CERTAIN 2007 - 2010 EDGE VEHICLES – PASSENGER AIRBAG MODULE REPLACEMENT

OVERVIEW

FIGURE 1

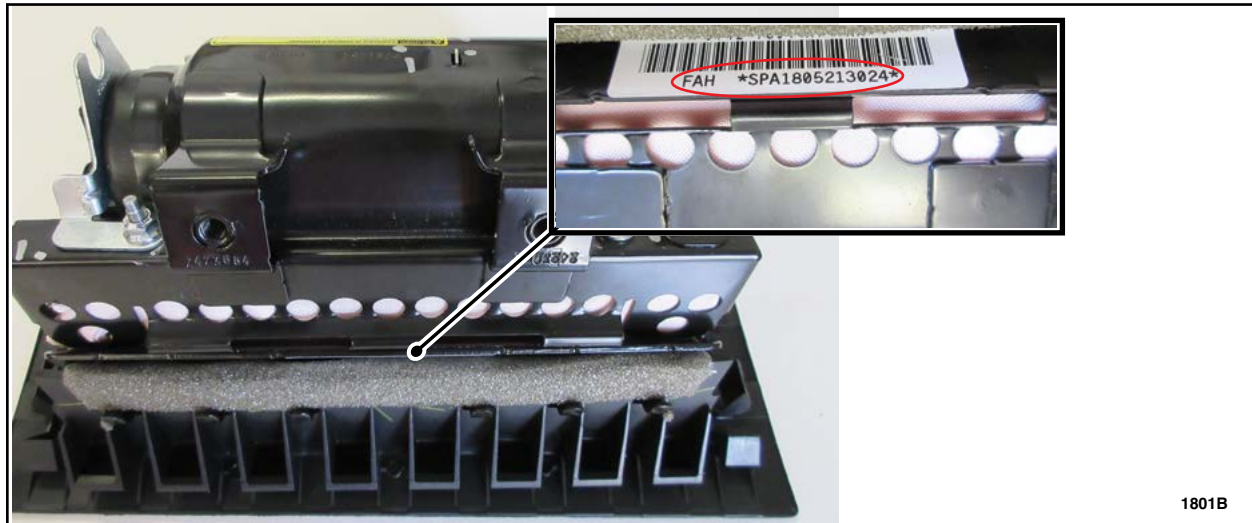
1. Record the 13 character serial number of the new airbag module on the repair order. See Figure 1.
2. Replace the passenger airbag module. Refer to section 501-20B of the Workshop Manual.
